Interior Renovations-Phase 1

John W. Boddie House

Tougaloo College

ADDENDUM NO. 3:

1 SECOND FLOOR RCP/
FIRE SPRINKLER LAYOUT DIAGRAM

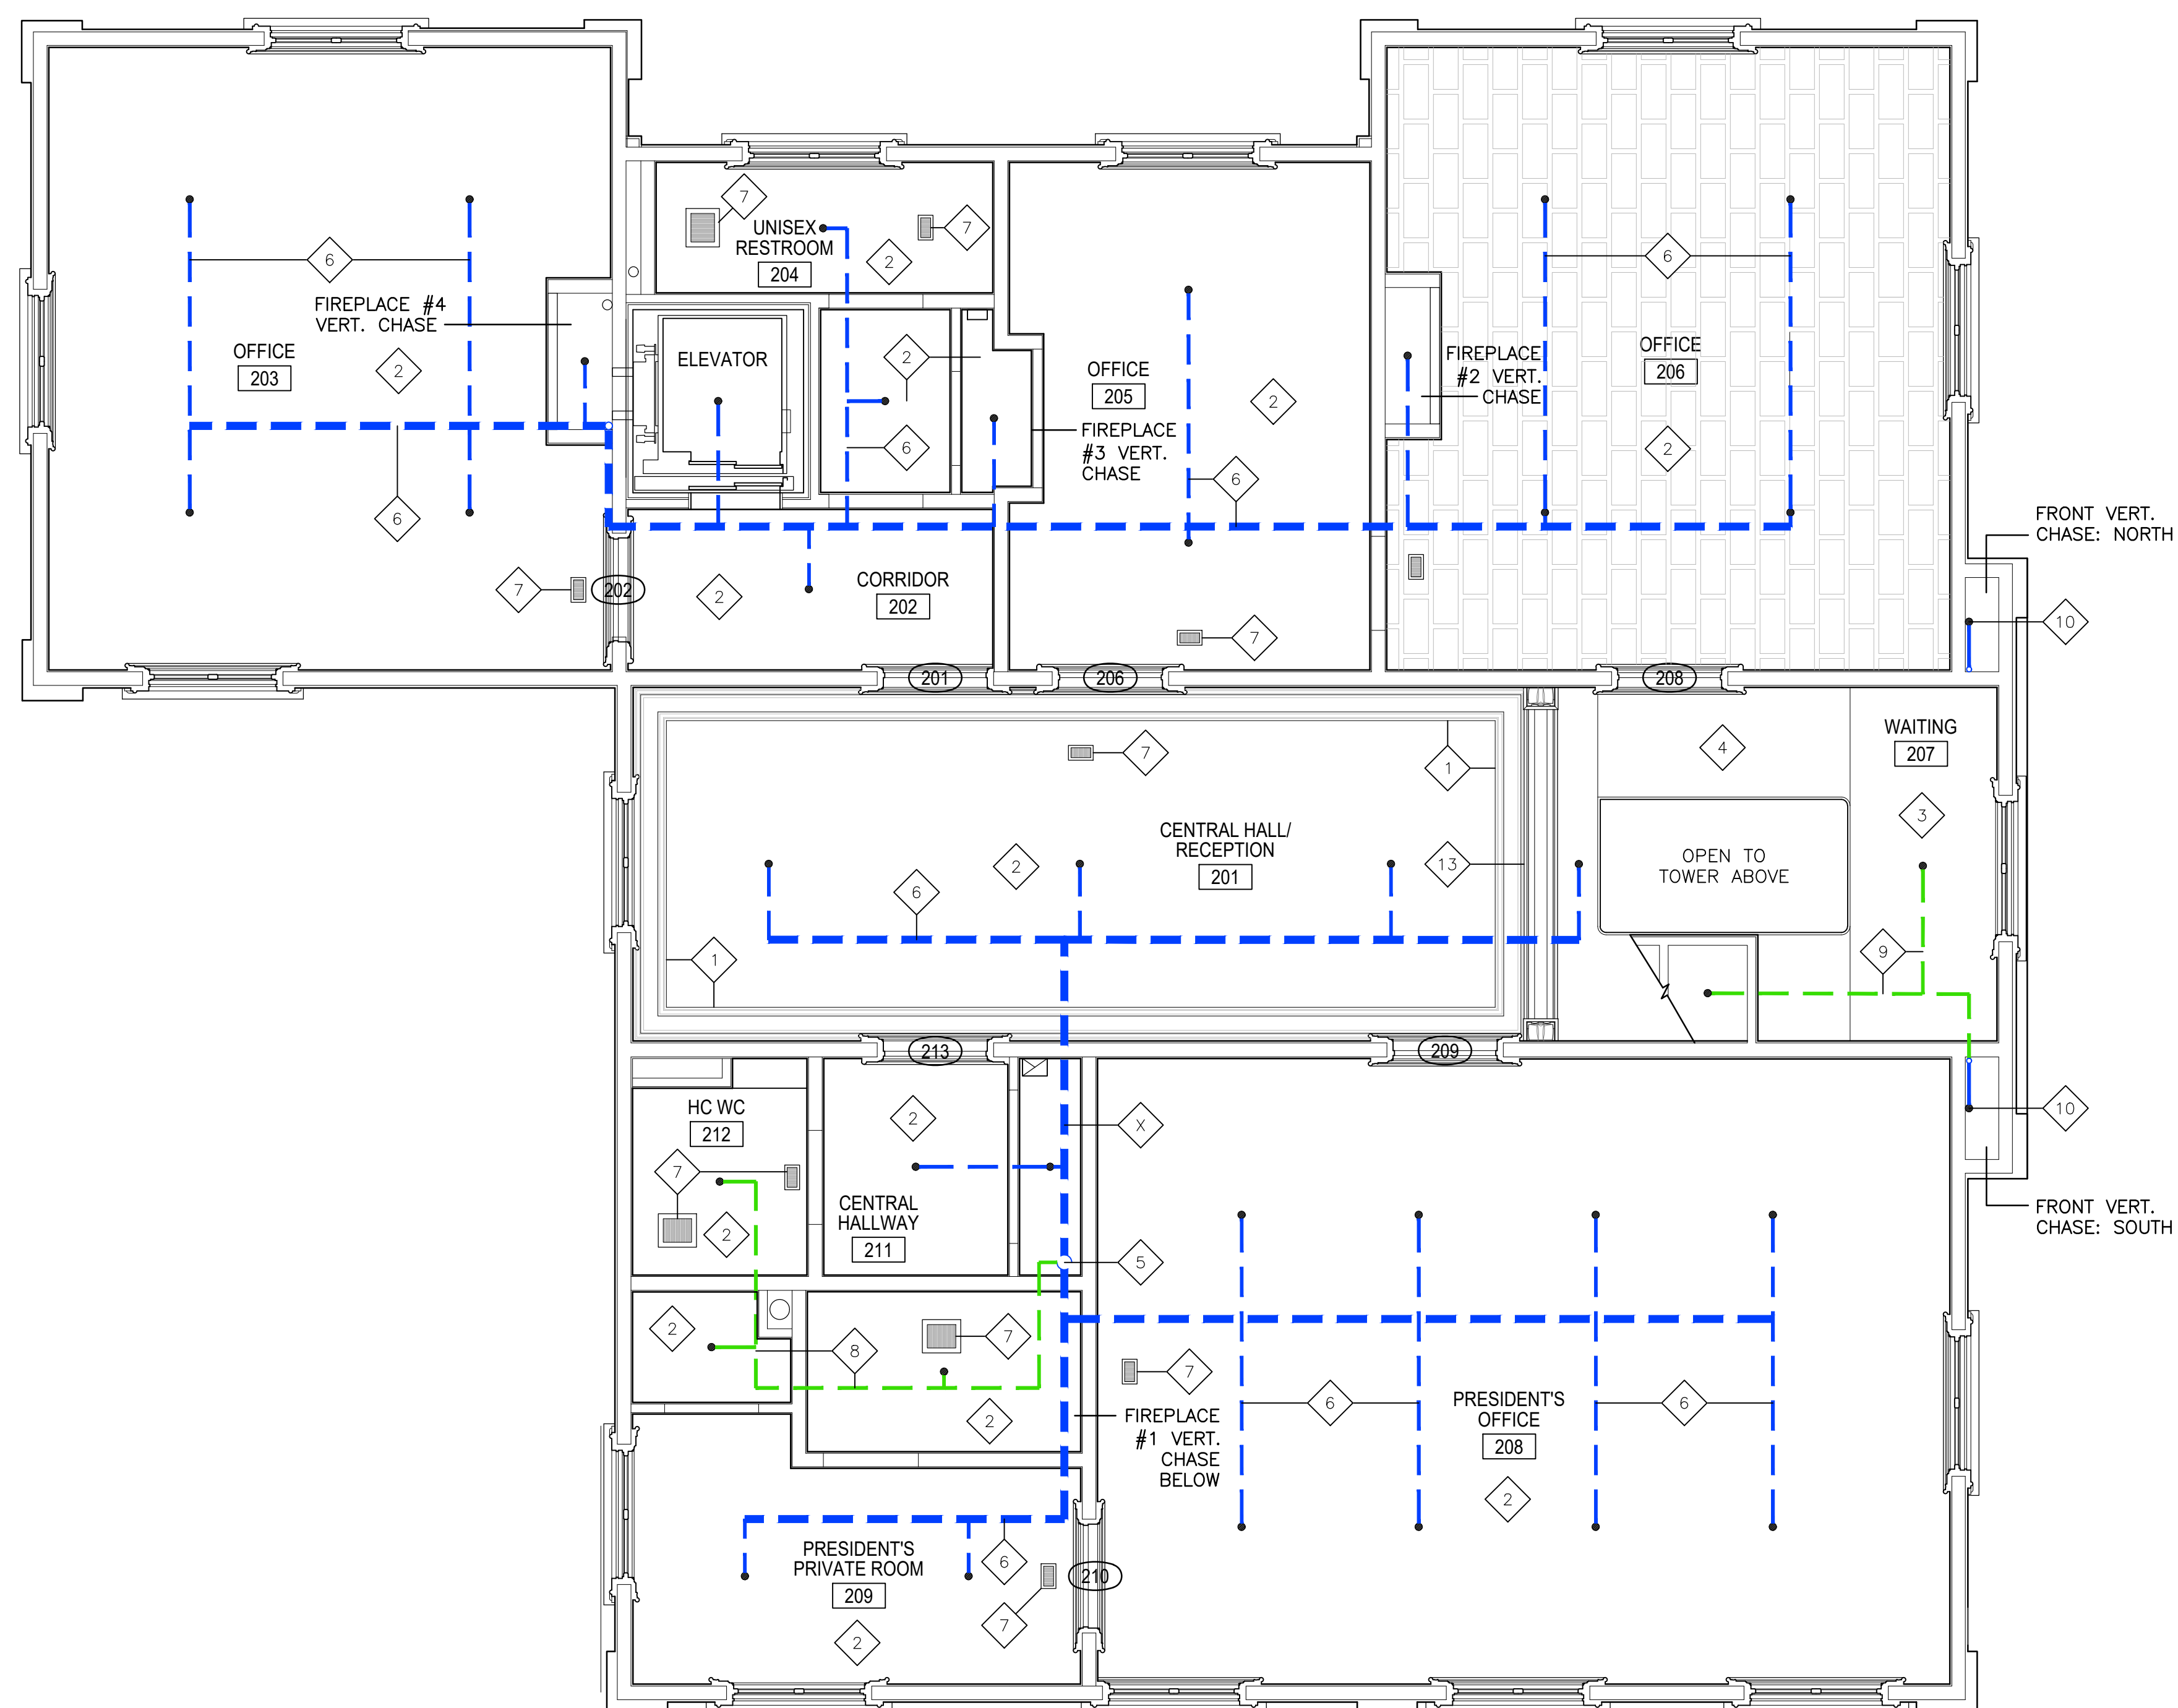
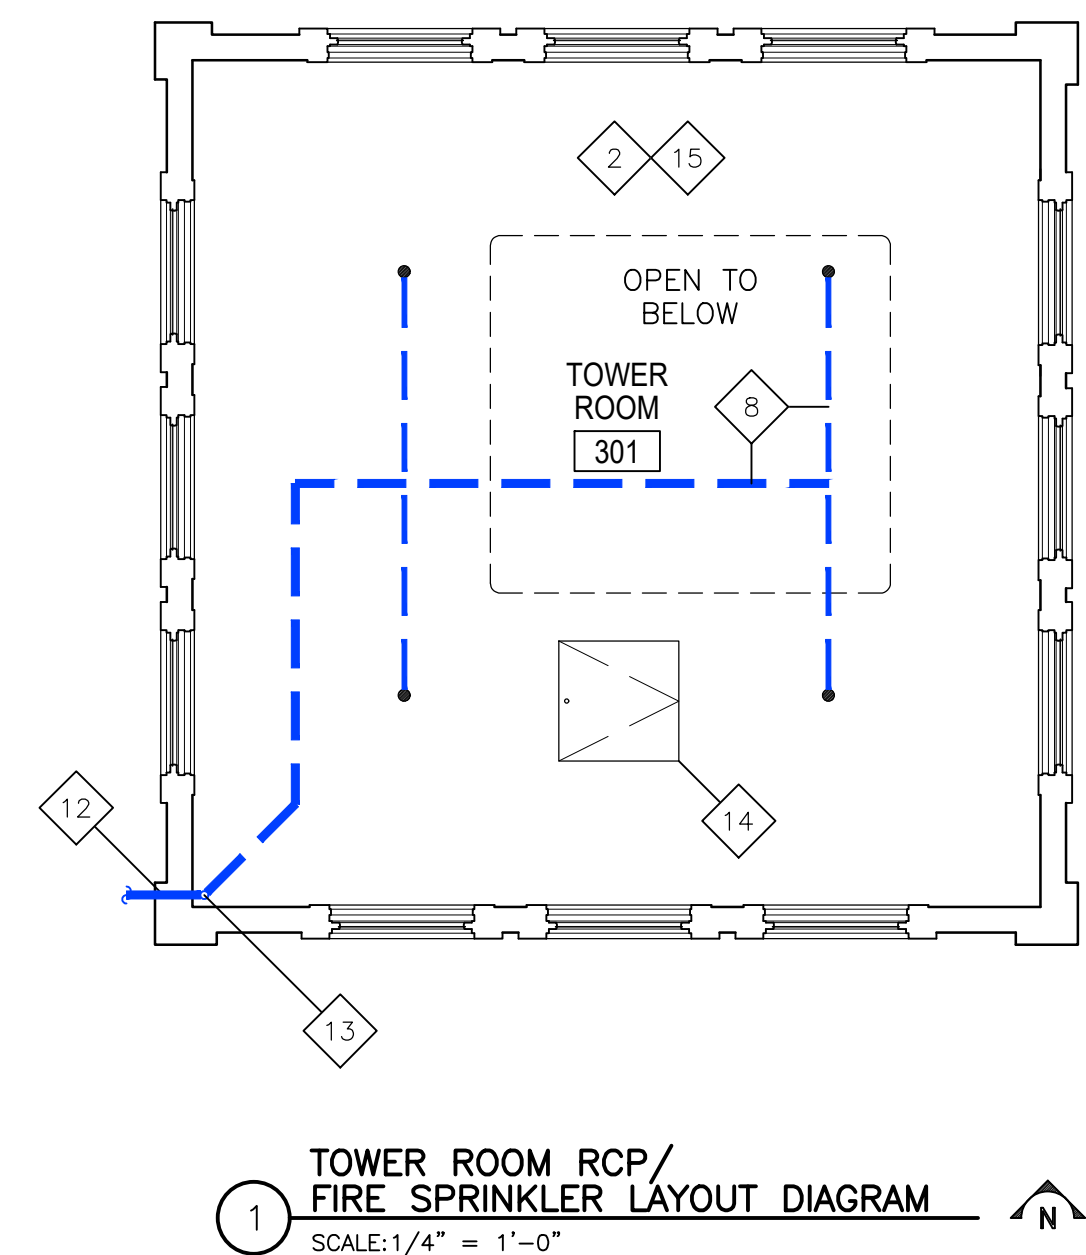
Replace the existing Sheet A1.6 with the revised sheet included in this addendum as Attachment No. 3
